TECHNICAL SERVICE BULLETIN

reissue No.LD310-001/2004
29 October 2004

Subject/Concern:	Defender Td5 Poor Starting/Noisy Fuel Pump
Model:	
Defender (LD)	VIN Range: 4A 659872-4A 661642

E56155

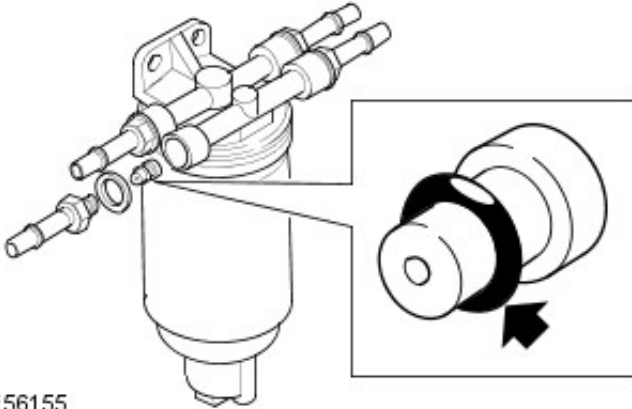
1. Confirm that the O-ring described is at fault:
2. Prepare for diesel fuel spillage in the area around the in-line fuel filter assembly (right rear wheel arch area).
3. Remove the fuel return pipe from the fuel filter (white coded connector).

- Using a 19mm spanner, unscrew the brass adaptor from the assembly.

- Withdraw the air bleed valve from inside the brass fitting. Inspect the O-ring and plastic body for splits and damage.

- If the O-ring is damaged, renew parts provided in the service repair kit.
- Prime the fuel system using the ignition cycling procedure described in the Owner's Handbook (Driving and Operating / Fuel Filling / Empty Fuel Tank).
- Run the engine for 10 minutes to purge all air from the fuel system.
